RE: Georgetown, CA – 01-14-16 Dollar General Project Appeal Hearing Continuation
Response/Action Letter Addendum
APN's: 0613620110, 0613620210, and 0613620410

SUBJECT: EDC FILE #15-1409
RESPONSE TO PUBLIC COMMENTS
JANUARY 14, 2016 EDC PLANNING COMMISSION MEETING
PROPOSED DOLLAR GENERAL MARKET STORE
SEC MAIN STREET & HARKNESS STREET
GEORGETOWN, CALIFORNIA

RE: Georgetown, CA – 12-10-15 Dollar General Project Appeal Hearing Response/Action Letter
APN's: 0613620110, 0613620210, and 0613620410

SUBJECT: El Dorado Design Review
Dollar General, Georgetown, CA

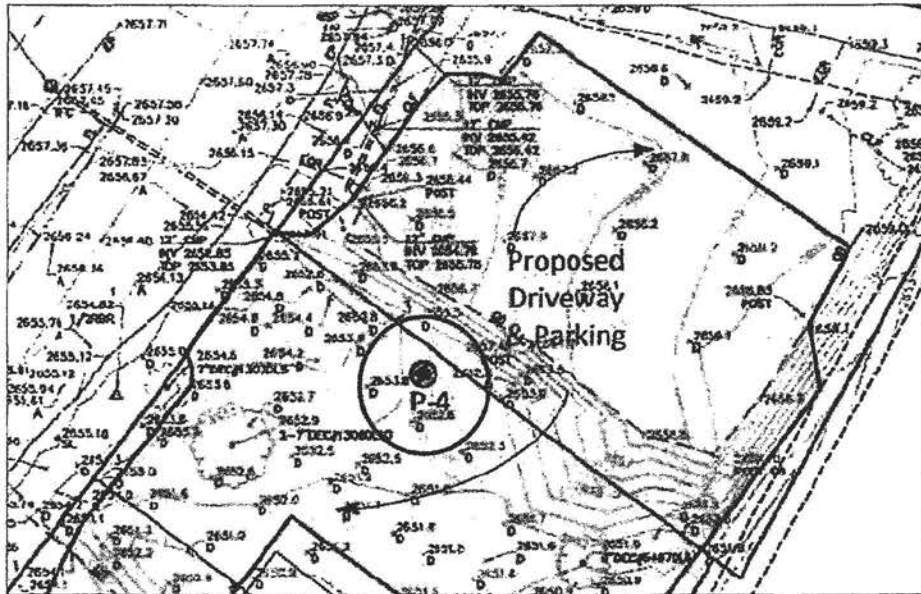
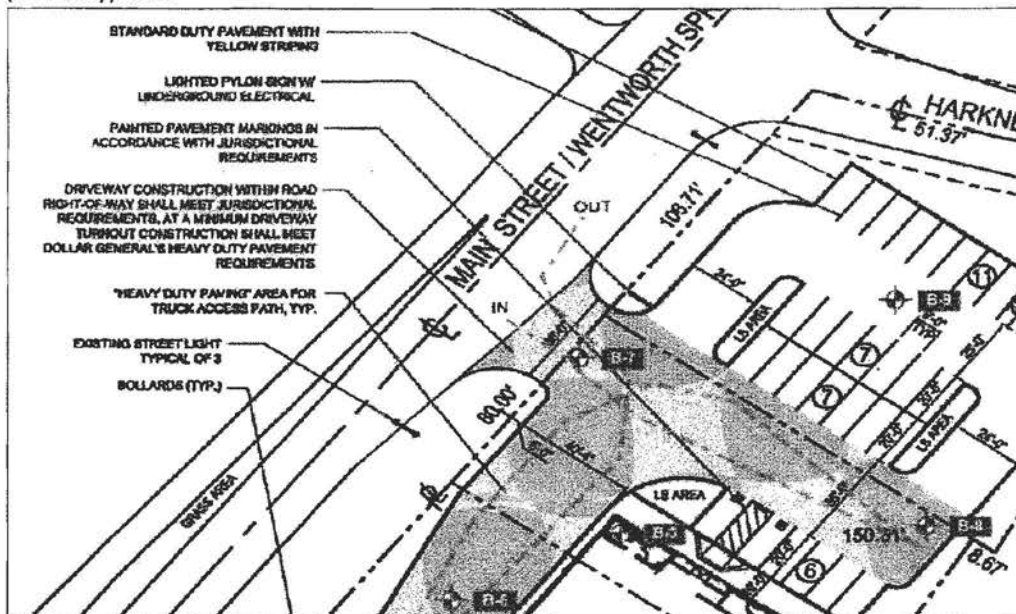
- **Percolation tests revealed a percolation rate of 32, 143, 165, and 231 min/inch (mpi) for four (4) borings;** it was noted *"the near surface soils have poor absorption characteristics, with equivalent percolation rates of approximately 140 to 230 mins/inch."* It should be noted **the percolation rate of 32 mpi was from a boring site that appears to be in a location planned for the driveway/parking lot**—but was described as *"...an area available for dispersal system expansion, if required."* (See P4 below and on following page.)

The following describes the paved driveway / parking areas more clearly; P4 seems to be in the paved (driveway) area.

- It was noted, "The percolation rates will deteriorate over time due to the soil conditions..."
- The scope of the engineering firm's services "...did not include a groundwater study..." (EAS Professionals, South Carolina; subcontracted to Salem Engineering Group, Inc., Fresno.)
- There was on-site evidence of "seasonal saturation at an approximate depth exceeding 48 inches" in the soil profile pit.

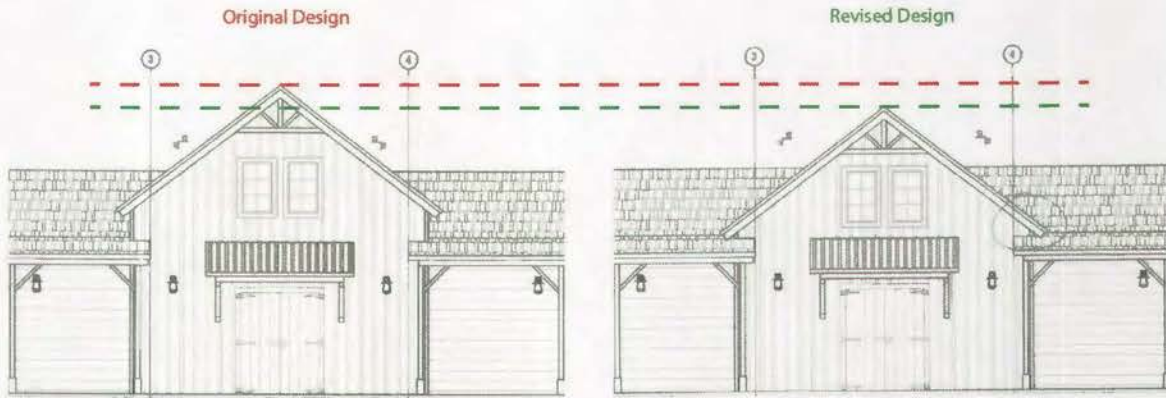
After much discussion of the look and placement of the building, there were 3 main items that sparked Commissioner comments.

- 1) The height of the architectural tower elements
- 2) The preference for a continuous covered walkway along the Main St. frontage of the building, and
- 3) The placement of the building on the site with regard to Main St. and the location of the trash enclosure.

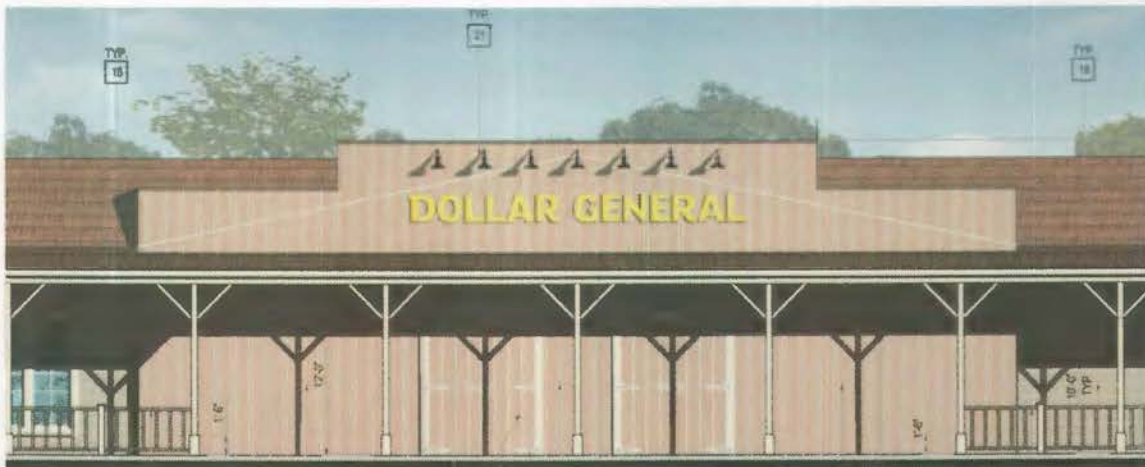
- 1) Height of the Architectural Tower Element – We have lowered the gabled roof elements by 30". As described in an attached letter by the architectural design firm, MPA Architects, lowering the gabled roof elements 30" is the maximum it can be reduced without negatively affecting: the shed roof underneath (as illustrated below), the aesthetics and the Dollar General signage. We have attached a new color rendering of the elevations that include this

feature change for your consideration.

- 2) Preference for a Covered Walkway – We have added this feature as shown in the color elevation rendering mentioned previously, though we (and our architects) strongly believe that it detracts from overall aesthetic appeal of the building (also noted in the letter from MPA Architects).

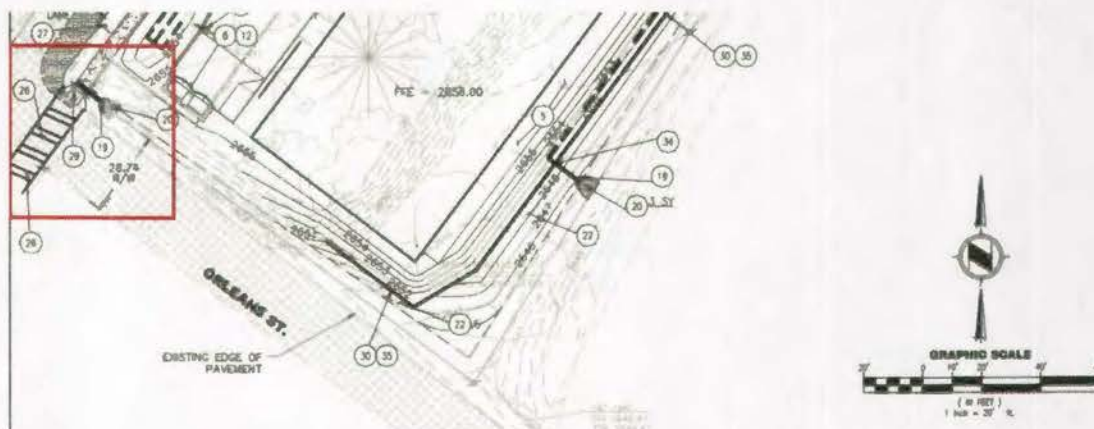
As one of the concerns discussed was the location of the trash enclosure and its visibility from Main St., we have provided a color elevation of the trash enclosure showing how we intend to screen it using the landscaping elements on the landscape plan. See below for a snippet of the file and please refer to the attached trash enclosure elevation for more detail.
